MAGNASTOR®

FINAL SAFETY
ANALYSIS REPORT
Amendment 7
Responses to
Request for
Additional Information

Docket No. 72-1031

**NAC INTERNATIONAL
RESPONSE TO THE
UNITED STATES
NUCLEAR REGULATORY COMMISSION**

Figure 4.10-3 Maximum Fuel Temperature vs. Time for Vacuum Drying – 30 kW Case

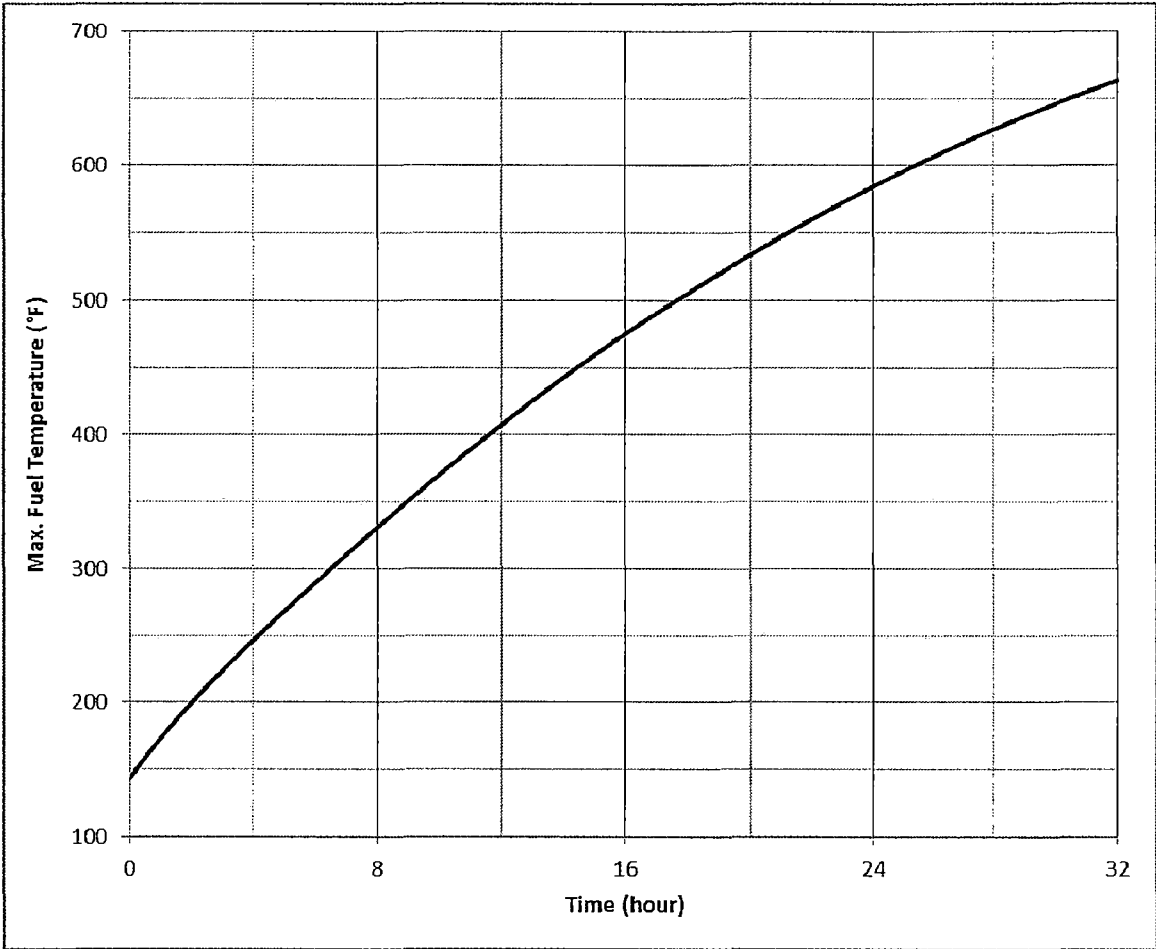
In reviewing past submittals on the MAGNASTOR storage system for background and completeness, the staff noted that the component temperatures of the fuel and the basket were significantly lower than the same component temperatures for the new PMTC. Based on the safety analysis report (SAR) text provided to the staff, it is not evident within the modeling approach why there should be such a large delta in those temperatures given that the only design change from the MAGNASTOR Transfer Cask is the neutron shield material.

Specifically, the NRC staff refers the applicant to Table 4.4-9, for the 30 kW case which reports component temperatures for the fuel and basket as 643° F and 614° F (637° F and 608° F in Rev. 0) respectively, and the 30 kW case presented in the unlabeled table at the bottom of pp. 4.10.2-1.

A transient analysis is performed for 32 hours and 54 hours for the heat load case of 30 kW and 25 kW respectively. A steady state analysis is performed for the 20 kW case. A summary of the maximum temperature for the fuel cladding and the basket is provided in Table 4.10-1. The maximum fuel temperature as a function of time for the vacuum drying for the 30 kW case is shown in Figure 4.10-3.
